# UtahAmerican Energy, Inc.

Re: UtahAmerican Energy, Inc. Horse Canyon Mine 07-001 C/007/013.

# Application for Permit Processing Detailed Schedule of Changes to the MRP

Deficiency Task 07-001 Lila Canyon Portal Barrier Plan

Figure II-1

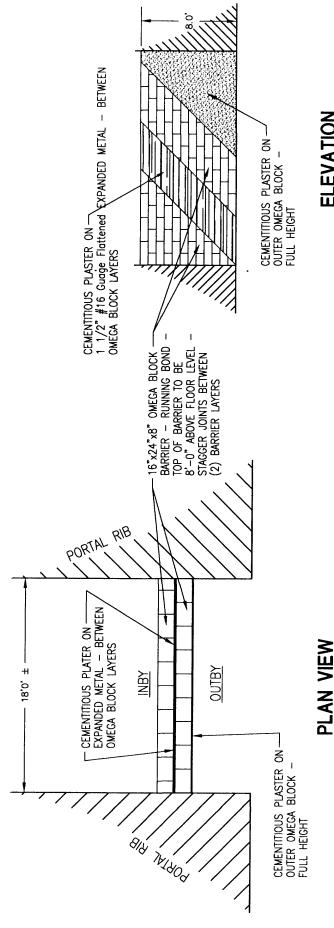
However, upon Phase III bond release it was discovered that the Lila Canyon permanent seals were in-by approximately 70' and it was decided to construct a barrier between the permanent seals and the outcrop. Figure II-1 located on page II-14A, shows the barrier construction plan.

However, upon Phase III bond release it was discovered that the Lila Canyon permanent seals were in-by approximately 70' and it was decided to construct a barrier between the permanent seals and the outcrop. Figure II-1 located on page II-14A, shows the barrier construction plan.

Upon Phase III bond release it was discovered that the Lila Canyon permanent seals were in-by approximately 70' and it was decided to construct a barrier between the permanent seals and the outcrop. Figure II-1 located on page II-14A, shows the barrier construction plan.

This Plan will be implemented in conjunction with the first area helicopter drilling in the spring of 2007.

× × ∞ ∞ West Portal is 16' East Portal is 15' All Material will be flow in by helicopter. There will be "NO" suface disturbance during the consturction of the barriers.
